ROAD DESIGN MANUAL REVISIONS
July, 2019

CHAPTER 2E

Curb and/or Curb and Gutter Section Detail”

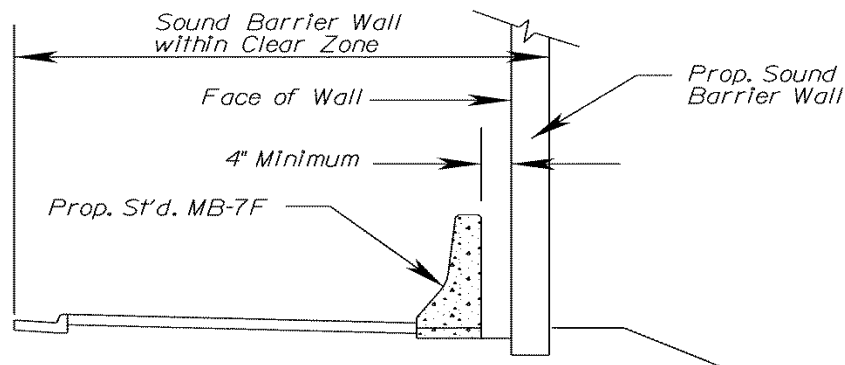
If Sound Wall is adjacent to the roadway shoulder then a Concrete Barrier Standard MB-7D shall be used, see detail below.”

Added the following language and detail: “*All sound barrier wall designs shall be submitted to the Central Office Location and Design Standards and Special Design (Engineering Services) Section.*”

If a sound barrier wall is located within the clear zone, sound barrier wall shall be shielded (protected) by concrete barrier. For RDM Clear Zone (Lateral Offset) Cases, See Appendix A, Table A-2-1.

When sound barrier wall is adjacent to a curb and/or curb and gutter section the wall shall be shielded (protected) with (MB-7F). For roadway shoulder section, sound barrier wall shall be shielded (protected) by median barrier (MB-7D).

Below are details depicting when shielding is required.
